The City of Spartanburg Design Review Board

AGENDA

Meeting Minutes of the Design Review Board (DRB)

PROJECT NUMBER

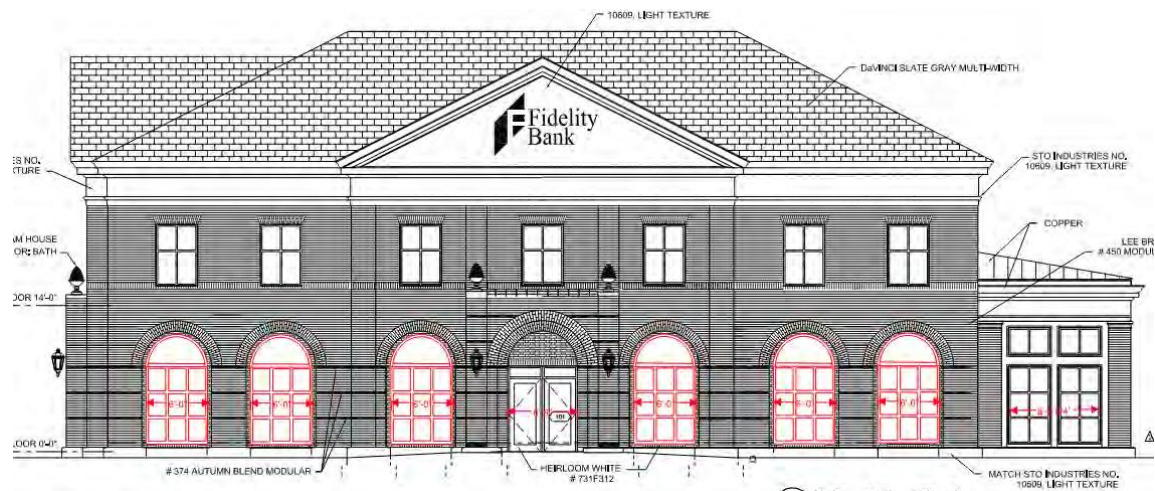
6.2.6 BUILDING ENTRANCES:

- *A functioning entrance for each ground floor tenant, operable during normal business hours for ingress and egress, is required along the primary street frontage. Buildings located on street corners are encouraged to have a corner entrance.*

While a corner entrance is encouraged, it is not required. The Church Street entrance is approximately 60 ft from the intersection.

PROPOSED RIGHT IN/RIGHT OUT WITH PEDESTRIAN REFUGE ISLAND

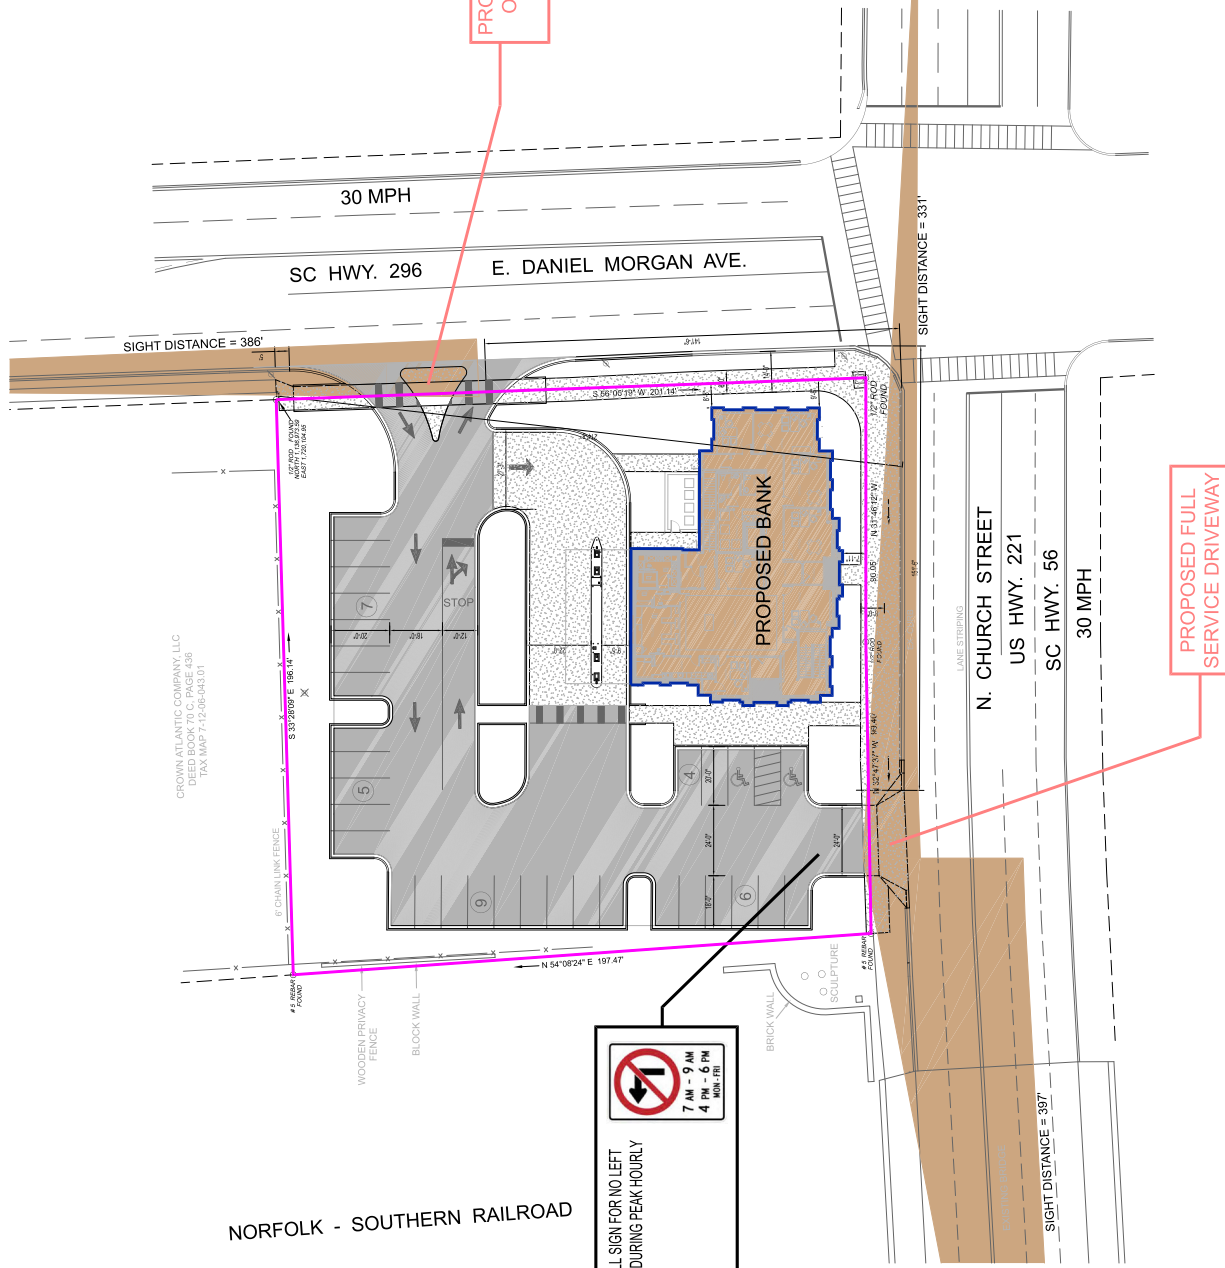
Right in/Right-out on Daniel Morgan Avenue: Staff views the right-in/right-out condition design can be enhanced. The Maximum Driveway Width in the Code of 24 feet is intended to minimize the length of a crossing by a pedestrian of a space where there are potential conflicts with vehicles. We believe that this condition can be resolved with a concrete median in Daniel Morgan Avenue in lieu of a high-speed turning radius. The City plans to pursue the median option with SCDOT.

In addition, staff requests the DRB support the City effort for the installation of a median in Daniel Morgan Avenue in lieu of the right-in/right-out driveway.

1 First Floor Plan
1/8" = 1'-0"

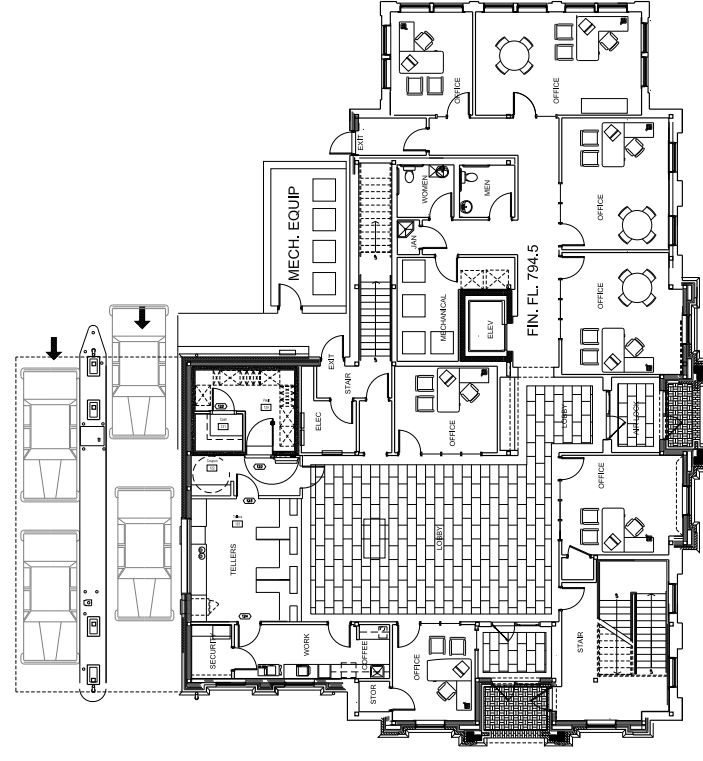
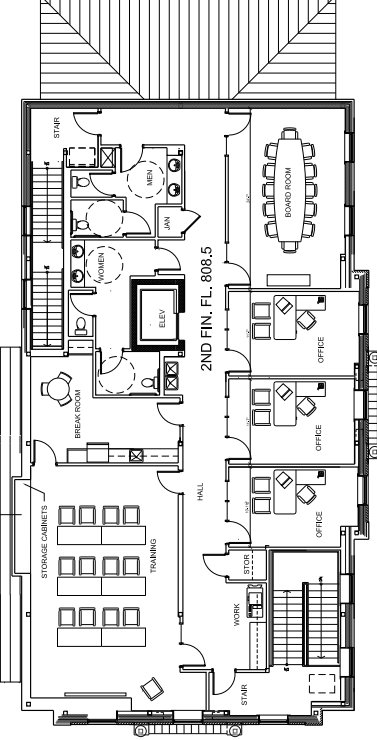
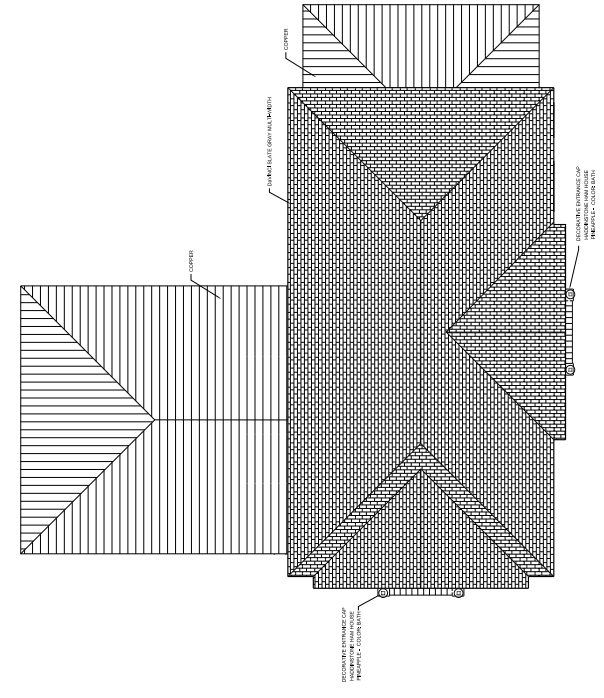
3. The front entry lobby has been widened and tile flooring extended out into the airlock to the street to provide a more open feel to the entry.
4. The one-story corner element has been revised to “sunroom” type feature as requested in the staff report.
